The Commission has issued the enclosed Amendment Nos. 79 , 75 and 48 to Facility License Nos. DPR-33, DPR-52, and DPR-68 for the Browns Ferry Nuclear Plant, Unit Nos. 1, 2, and 3. These amendments consist of changes to the Technical Specifications in response to your request of May 15, 1981 (BFNP TS 163), as supplemented by your letter of July 13, 1981.

These amendments revise the administrative controls section of the Technical Specifications to reflect changes in the TVA and Browns Ferry Nuclear Plant organizations.

AMENDMENT TO FACILITY OPERATING LICENSE

SAFETY EVALUATION BY THE OFFICE OF NUCLEAR REACTOR REGULATION

FIGURE 6.1-1

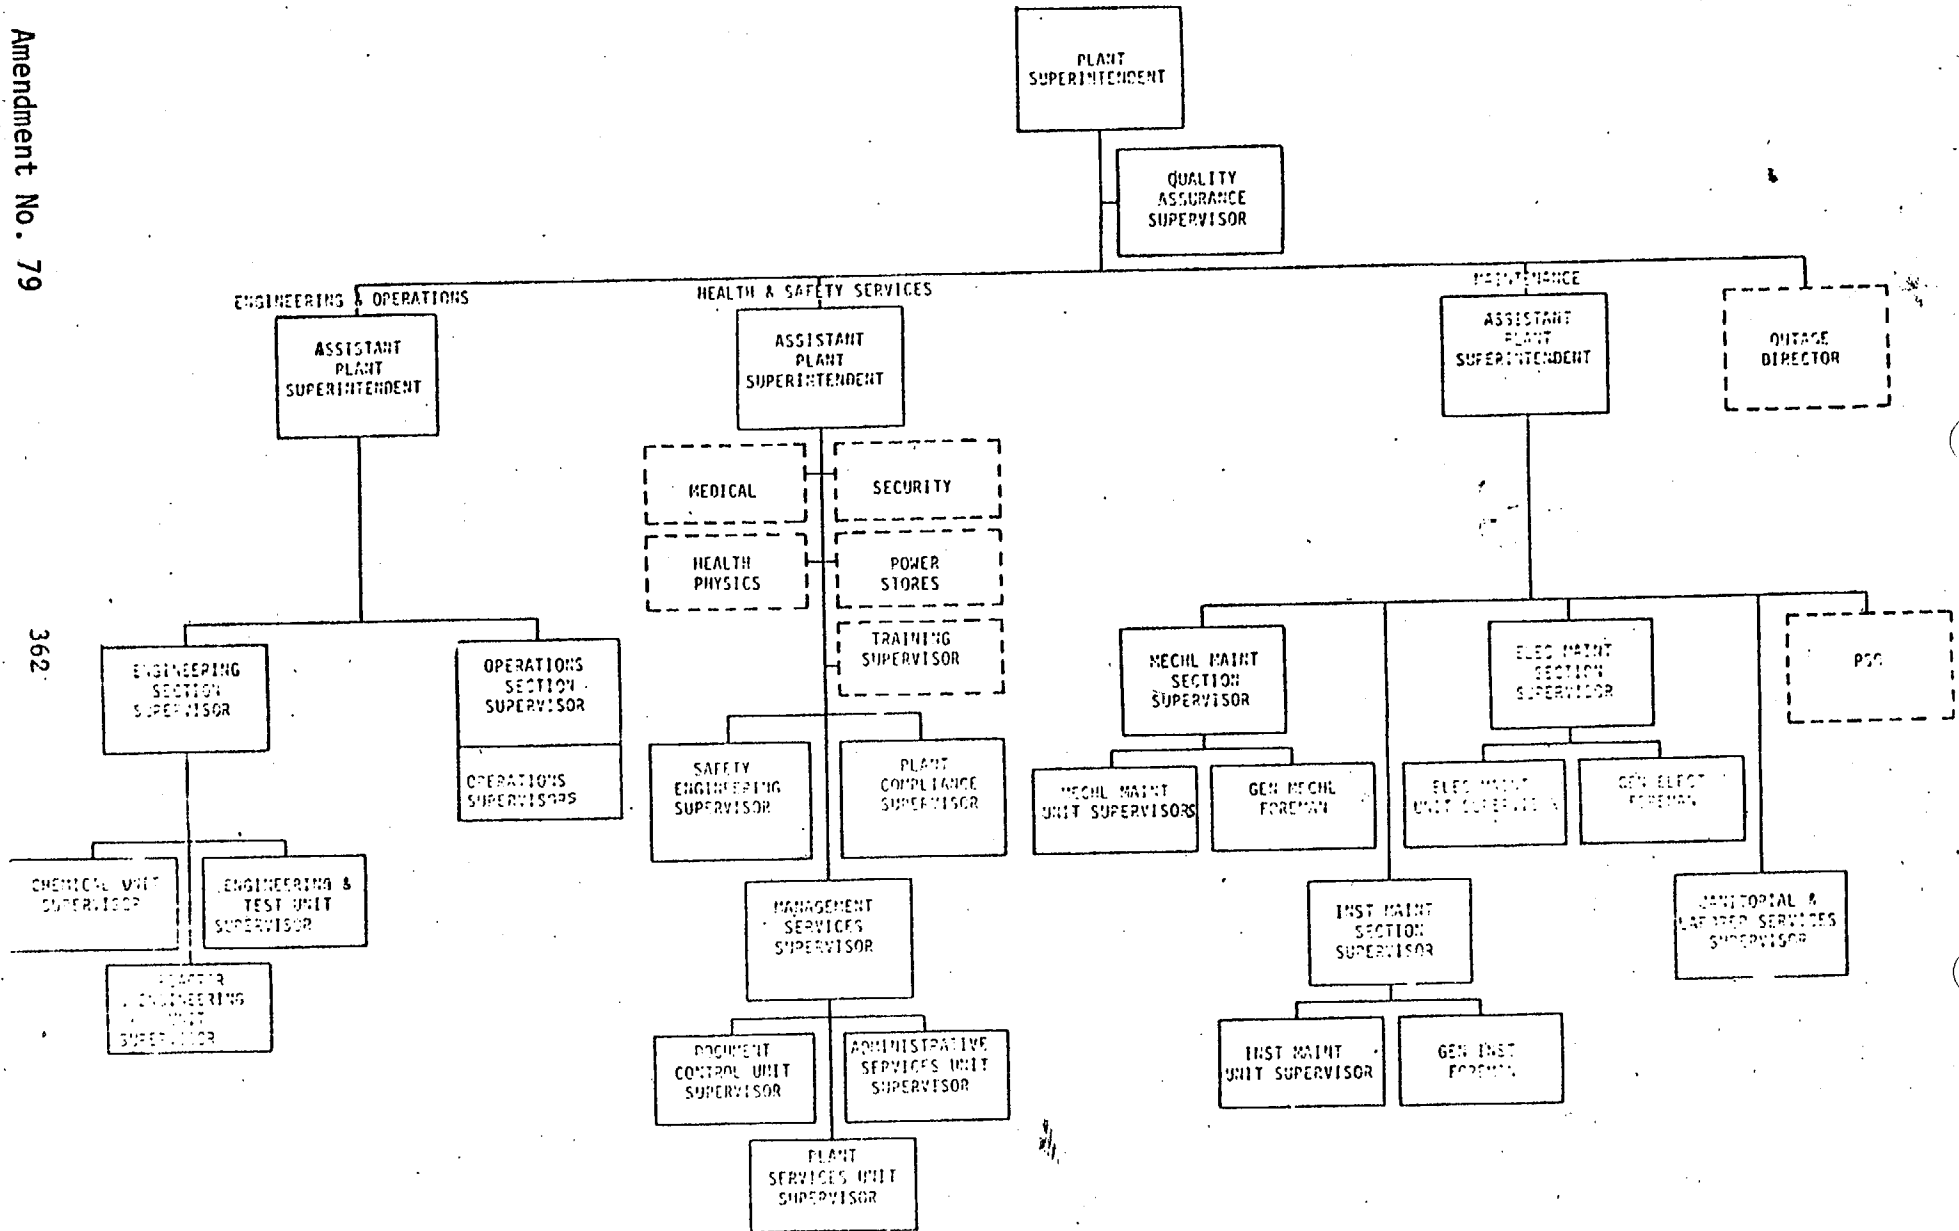
- a. Reflect that TVA's Division of Power Production has been separated into two divisions--the Division of Nuclear Power and the Division of Fossil and Hydro Branch. The former Nuclear Generation Branch is now the Division of Nuclear Power.

- B. The portion of TVA management which relates to the operation of the plant is shown in Figure 6.1-1.
- C. The functional organization for the operation of the station shall be as shown in Figure 6.1-2.
